## FIELD INSPECTION

<b>Project Name:</b>	<b>Mountain Valley Pipeline</b>	<b>Inspector:</b>	<b>Matthew Grant</b>
<b>Inspection Date:</b>	<b>Wednesday, September 26, 2018</b>	<b>Project Contact:</b>	<b>Brian Clauto</b>
<b>Spread: Franklin County</b>	<b>Spread I</b>	<b>Weather (Wet/Dry/Rain):</b>	<b>Wet</b>

# FIELD INSPECTION PHOTO LOG

Fig. 3

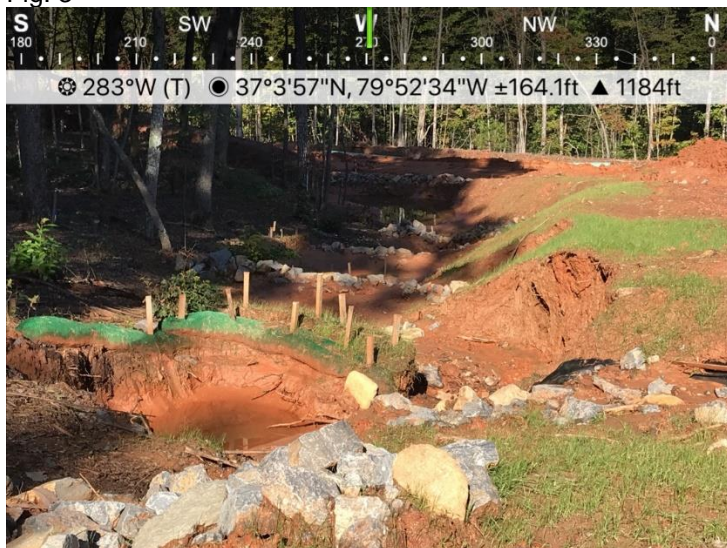
- **Area 1** – MP 269 St#14248+55 on going bridge repair.
- **Area 2** - MP 266 St#14059+00 rock check dams require repair & maintenance.
- **Area 3** - MP 266 St#14059+28 sump outlet conveyance channel requires stabilization.

All issues noted for maintenance & stabilization above were added to the daily corrective action punchlist.

**Deadline:** Within 24hr notification
